PROJECT NUMBER: SP 14-09 / CN 14-28

STREET IMPROVEMENT AND SITE PLAN
PROJECT: CARE FACILITY OREGON CITY
SP 14-09 / CN 14-28 / CU 14-01

DRAWING NUMBER: **C1**
SHEET 2 OF 8

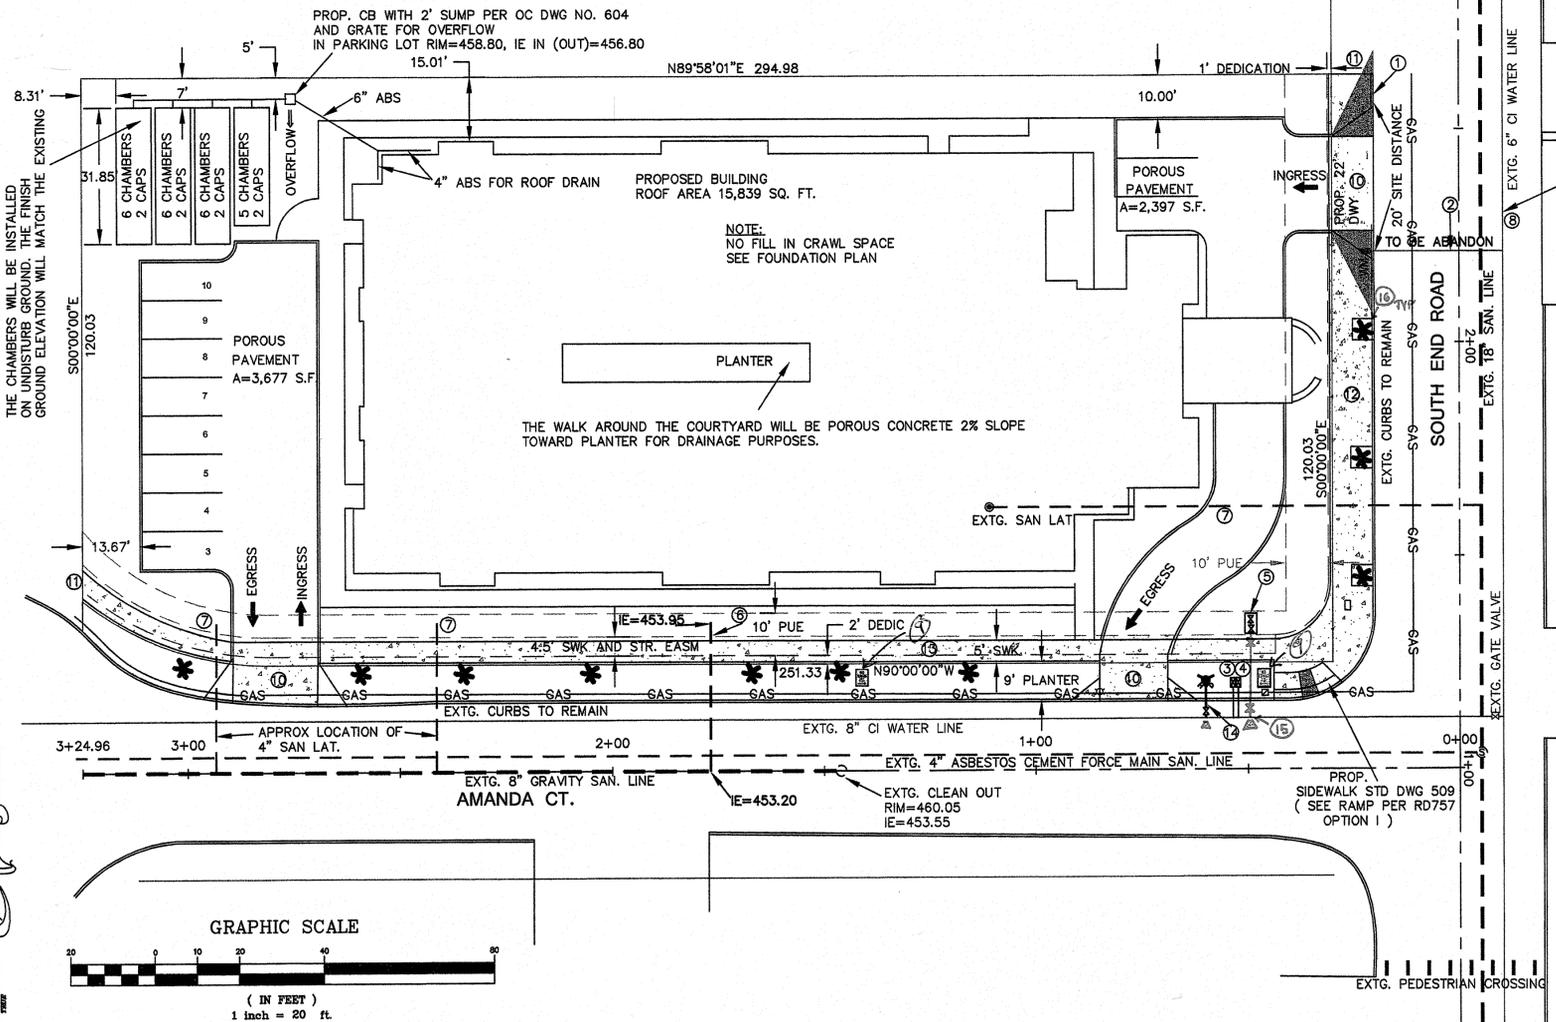
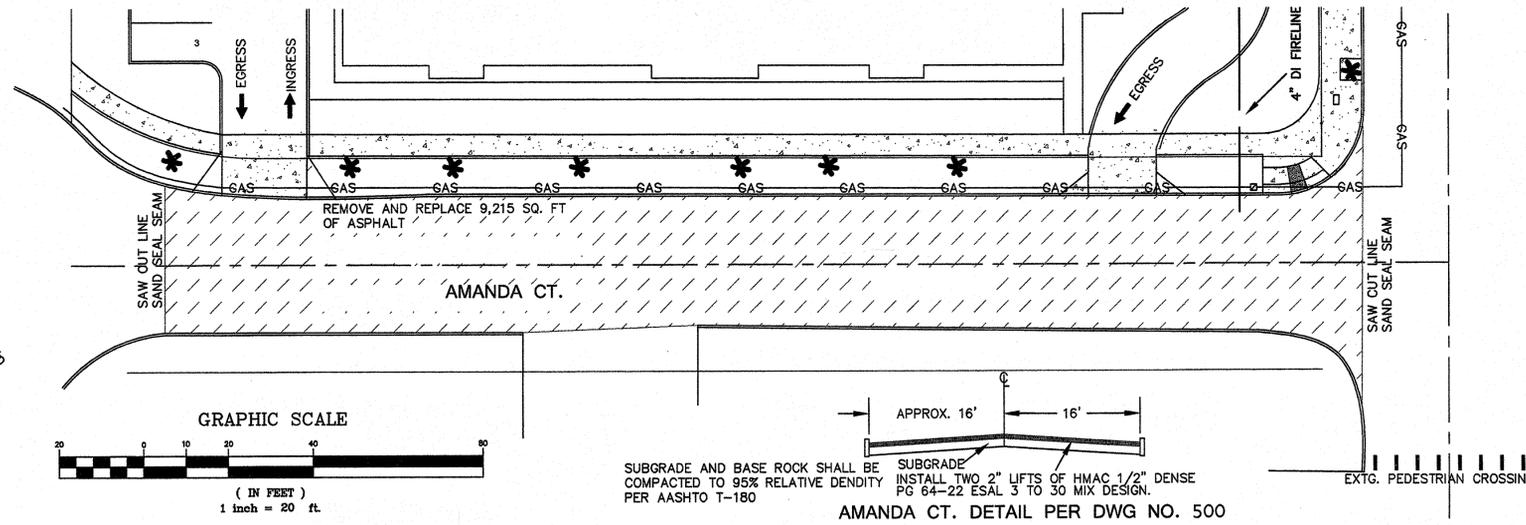
- ⑨ *Where? on plan?* INSTALL NO PARKING SIGNS 100 FEET APART PER MUTCC SIGNS DETAILS R7-1L AND R7-1R
- ⑩ STD COMMERCIAL DWY PER STD DWG 505
- ⑪ END OF SIDEWALK MARKER PER O.C. STD DWG NO. 525
